Woodhouse Garden Suburb, Brighouse LVIA

Appendix 7.3 Consultation Correspondence

Correspondence 18th February 2021

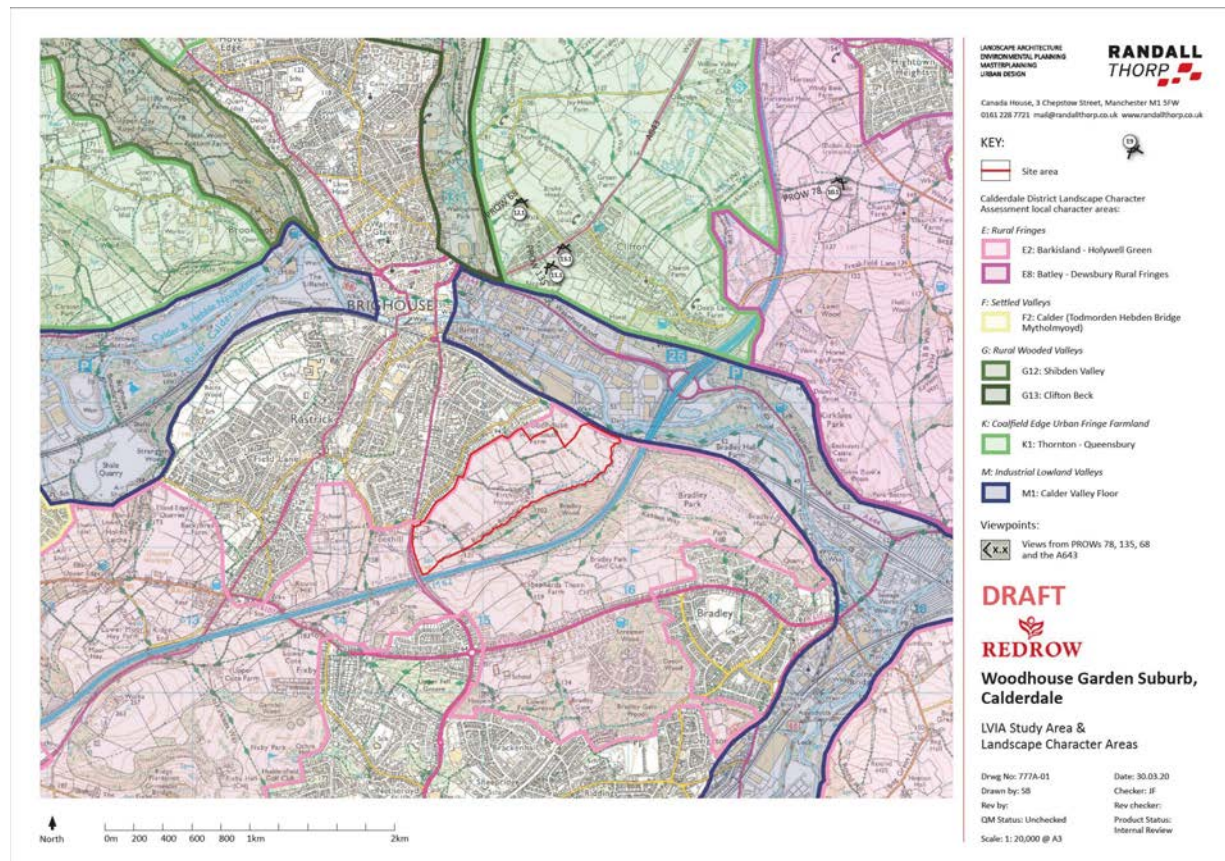
We are unsure if the notation is correct on the plans, the viewpoints are indicated but it would appear that the views being captured are in some instances up and down footpaths rather than across the site

As explained above points 6.2/6.3/6.4 appear to look up and down a footpath
